PLANNING & ZONING AGENDA ITEM REVIEW FORM

Discussion and possible action on any and all matters regarding Subdivision Case No. 2024-0298P. A request by Vega & Vega Engineering, on behalf of Von Verde Partners LLC, for the approval of Orchidea Park Townhomes Subdivision Phase 1 preliminary plat. The property is located at the southeast corner of 24th Avenue and County 24th Street intersection, in San Luis, Arizona.

Comment Letter dated July 5, 2024

ORCHIDEA PARK TOWNHOMES SUBDIVISION PHASE 1

A SUBDIVISION OF THE NE 1/4 OF SECTION 14, T11S, R24W,
G.&S.R.B.&M., YUMA COUNTY, ARIZONA.
MAY OF 2024 ACREAGE: 10.56 AC (NET)
PRELIMINARY PLAT

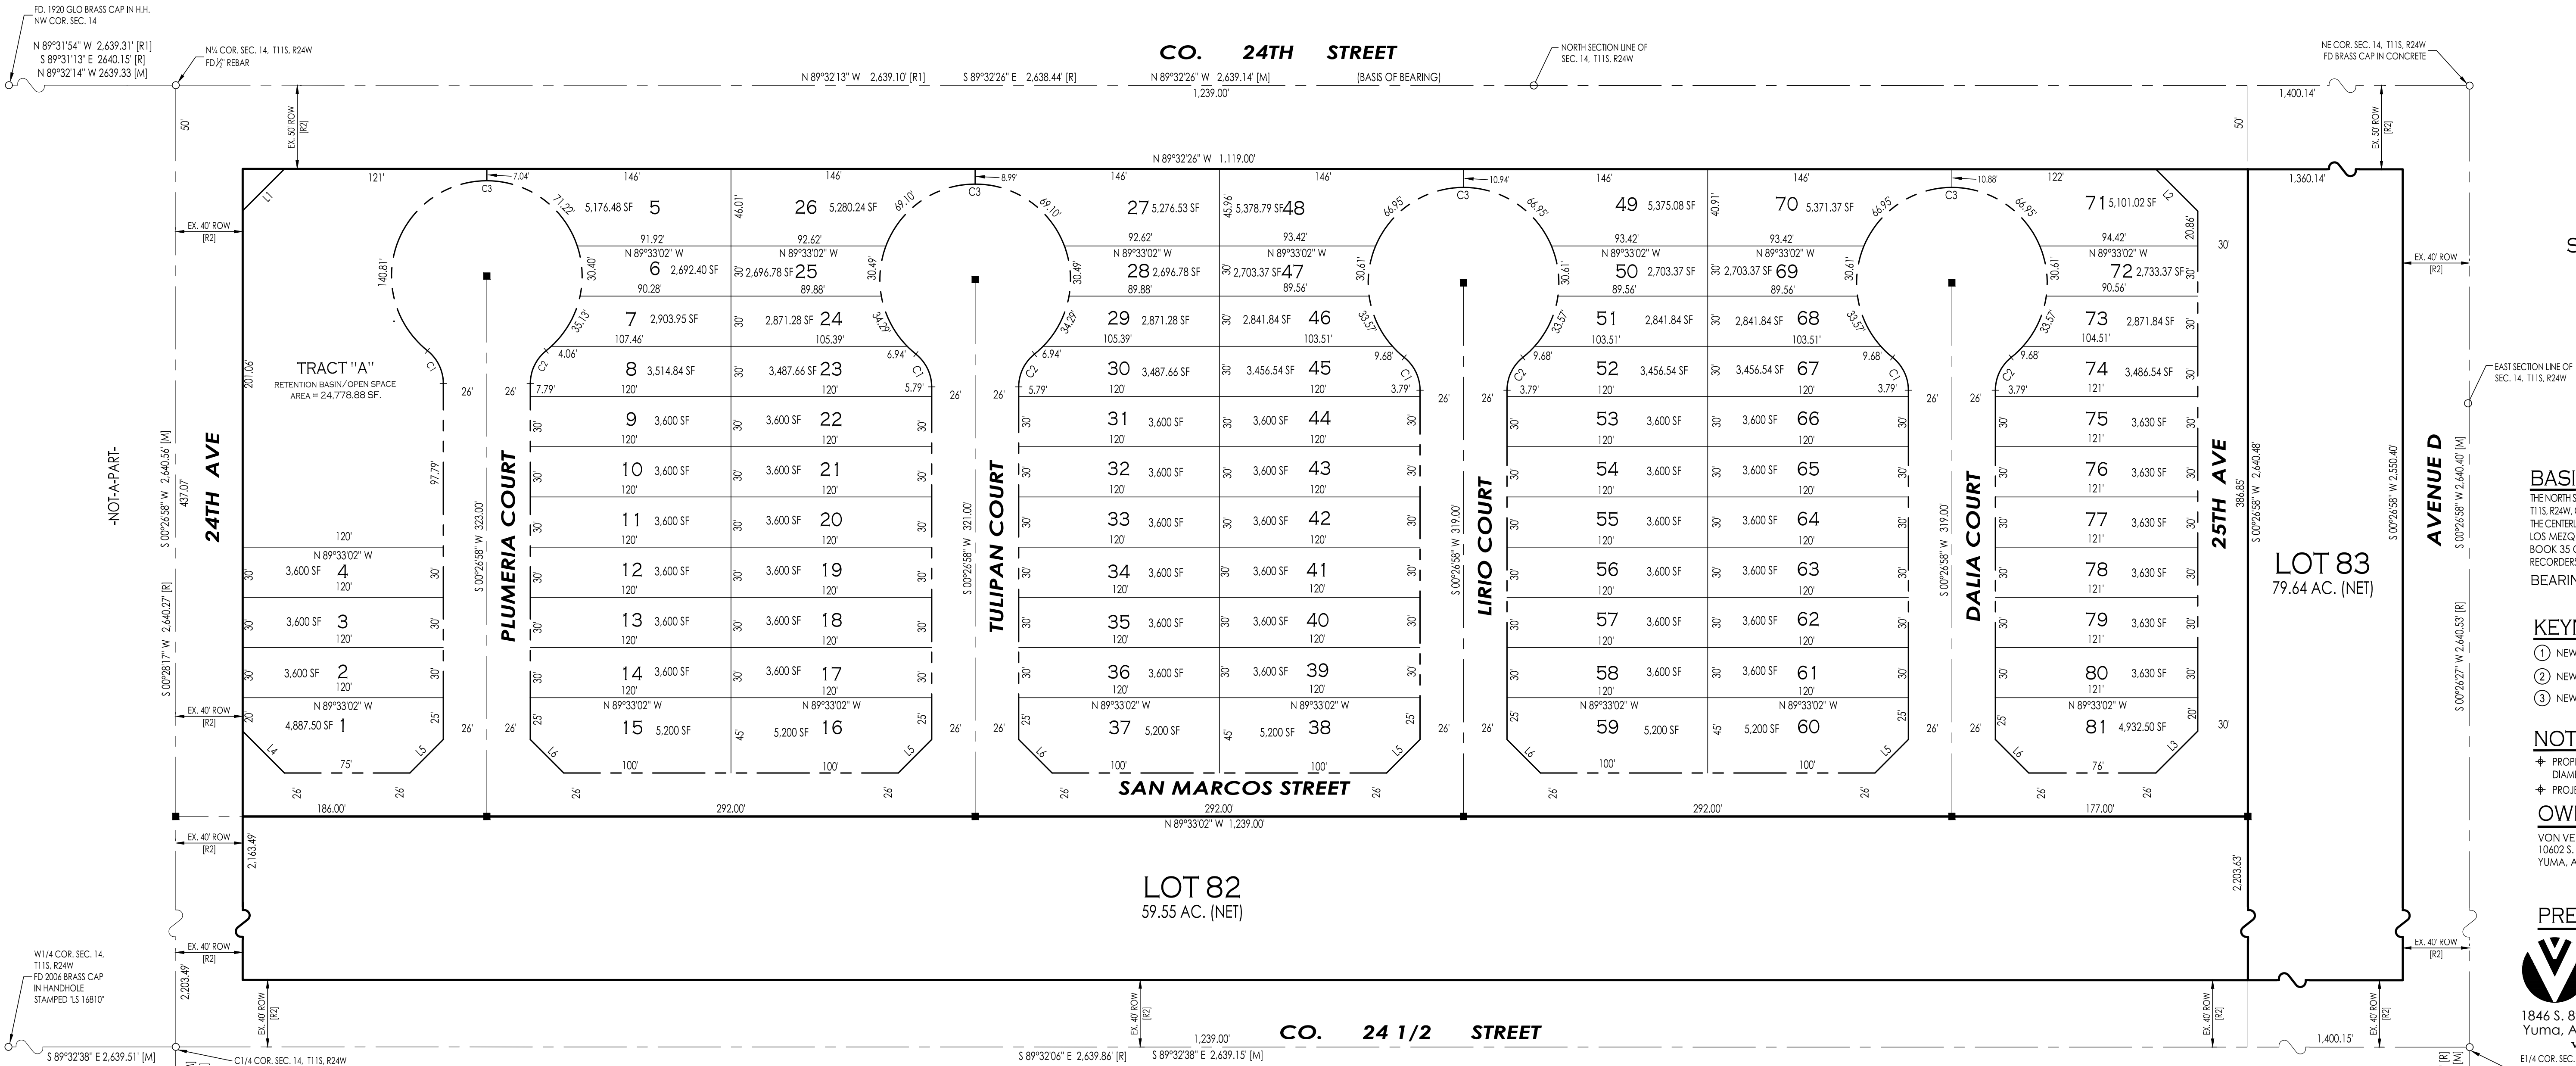
4. On Approved Section revise "Director of Planning and Zoning" to "*Director of Development Services*".
5. Call out the corners of the subdivision property and provide survey monuments at all corners.

6. Show 8' utility easement and 1' non-access easement on plat.
7. Show all dimensions and bearing as required for lots 82 and 83 and dedicate corner triangles at intersections as per COY standards.

10. Call out Mid-Section line of section 14.
11. Provide owners name and assessor's number of adjoining parcels.
12. Provide assessor's parcel number on plat and revise zoning to current zoning.

13. Basis of bearing is S89°32'13"W as per Book 35 of Plats, Page 54, Yuma County Records Office. Clarify or revise accordingly.

TYP. LOT BUILDING SETBACK LAYOUT

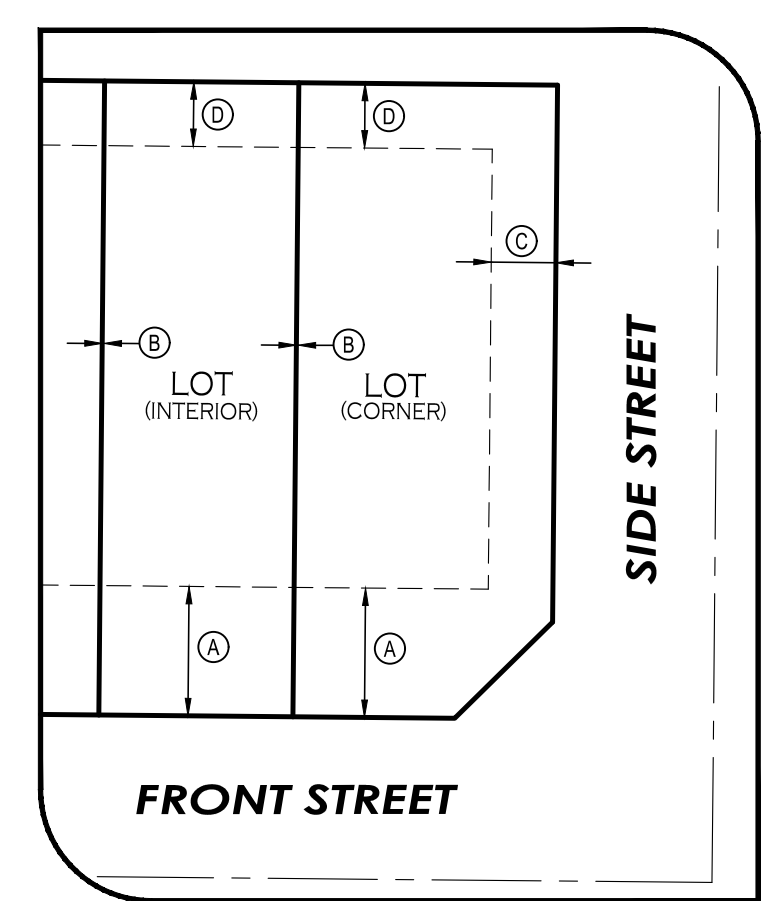
8. Legal description on plat and dedication should read: "A Subdivision of lot B of San Luis Port II Subdivision as recorded..."
9. On TYP. Lot Building Setback Layout show 10' side yard setback on visibility triangle.

A SUBDIVISION OF THE NE 1/4 OF SECTION 14, T11S, R24W,
G.&S.R.B.&M., YUMA COUNTY, ARIZONA.
MAY OF 2024 ACREAGE: 10.56 AC (NET)
FINAL PLAT

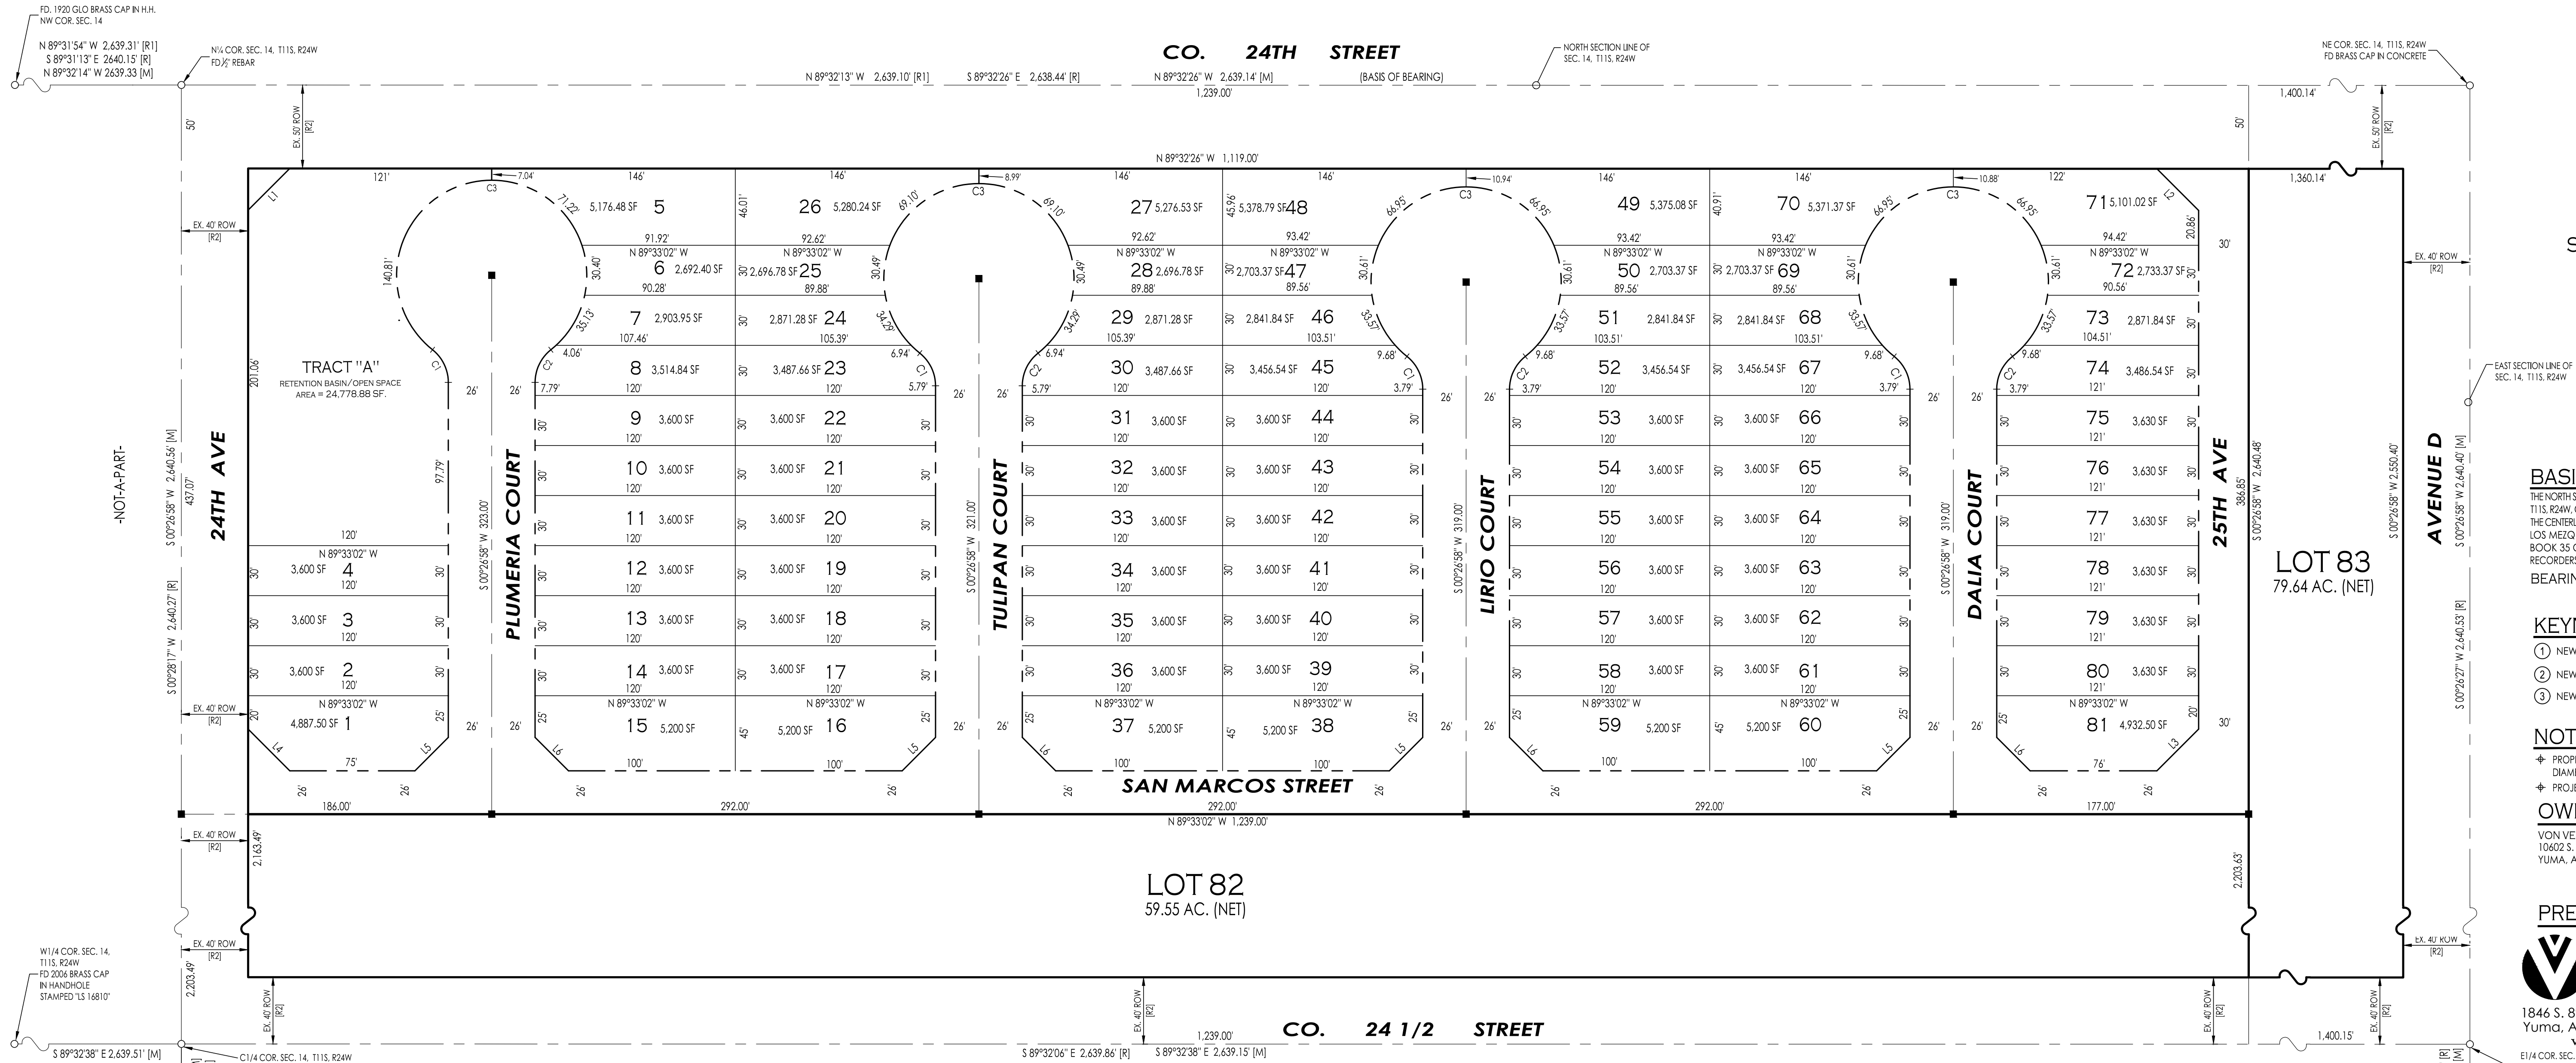
4. On Approved Section revise "Director of Planning and Zoning" to "*Director of Development Services*".
5. Call out the corners of the subdivision property and provide survey monuments at all corners.

6. Show 8' utility easement and 1' non-access easement on plat.
7. Show all dimensions and bearing as required for lots 82 and 83 and dedicate corner triangles at intersections as per COY standards.

10. Call out Mid-Section line of section 14.
11. Provide owners name and assessor's number of adjoining parcels.
12. Provide assessor's parcel number on plat and revise zoning to current zoning.

13. Basis of bearing is S89°32'13"W as per Book 35 of Plats, Page 54, Yuma County Records Office. Clarify or revise accordingly.

TYP. LOT BUILDING SETBACK LAYOUT

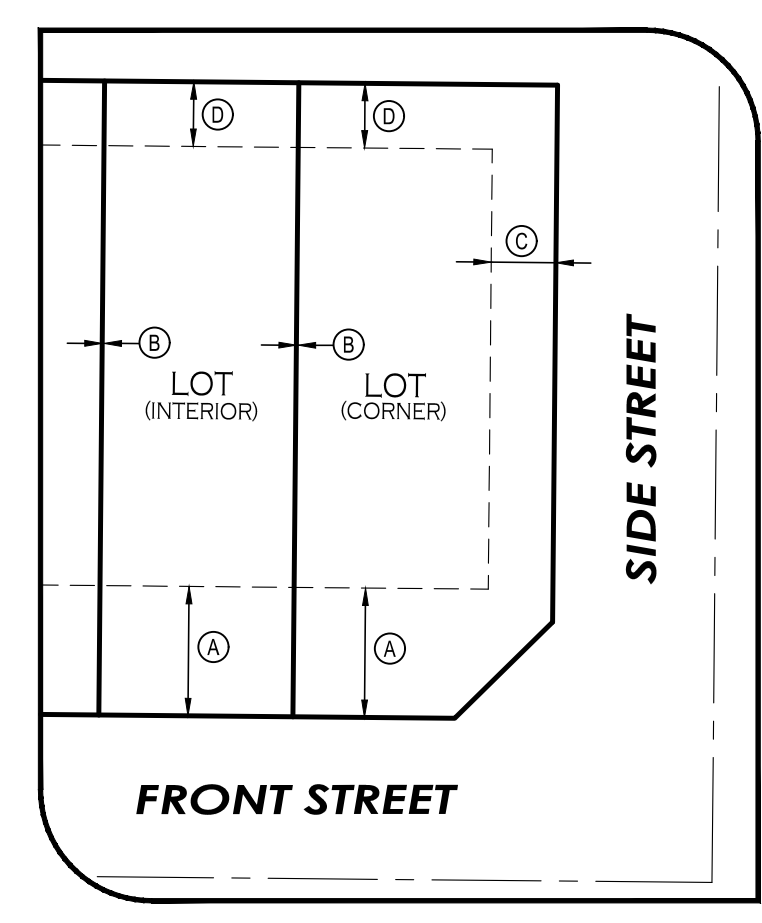
8. Legal description on plat and dedication should read: "A Subdivision of lot B of San Luis Port II Subdivision as recorded..."
9. On TYP. Lot Building Setback Layout show 10' side yard setback on visibility triangle.

GUARD POST DETAIL
E
3

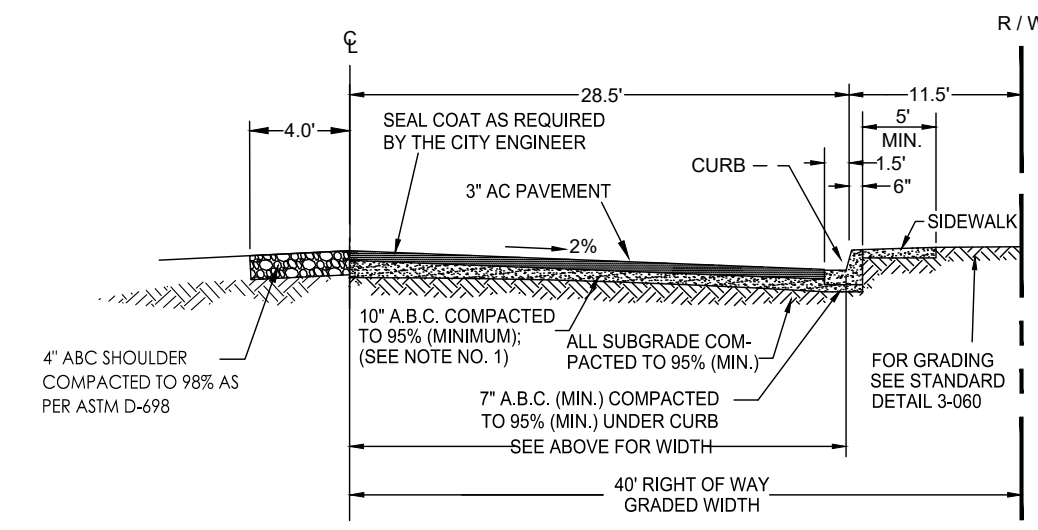
8. Provide guard post location and spacing on 13' spillways.
9. Provide distance from centerline for stormdrain pipes.
10. Provide subdivision perimeter wall along rear of retention basin.

24TH AVENUE
CITY OF YUMA STD. 2-020 (MODIFIED) NTS **C**
3

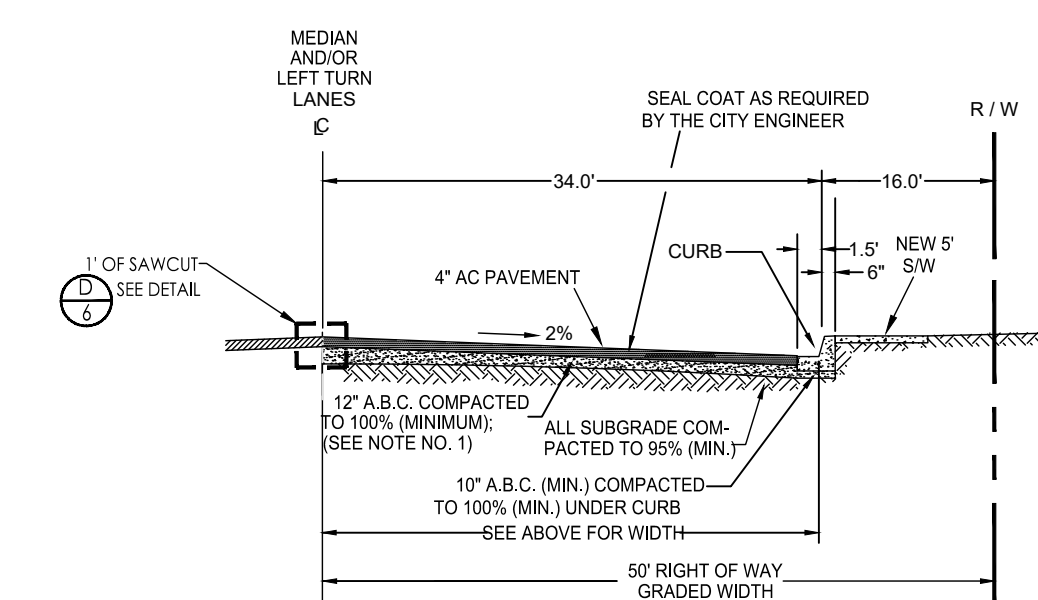
6. For 24th Avenue section to match northern developments with a centerline to curb dimensions of 26.0' and 5' sidewalk.
7. Reference detail to Keynote 7 accordingly.
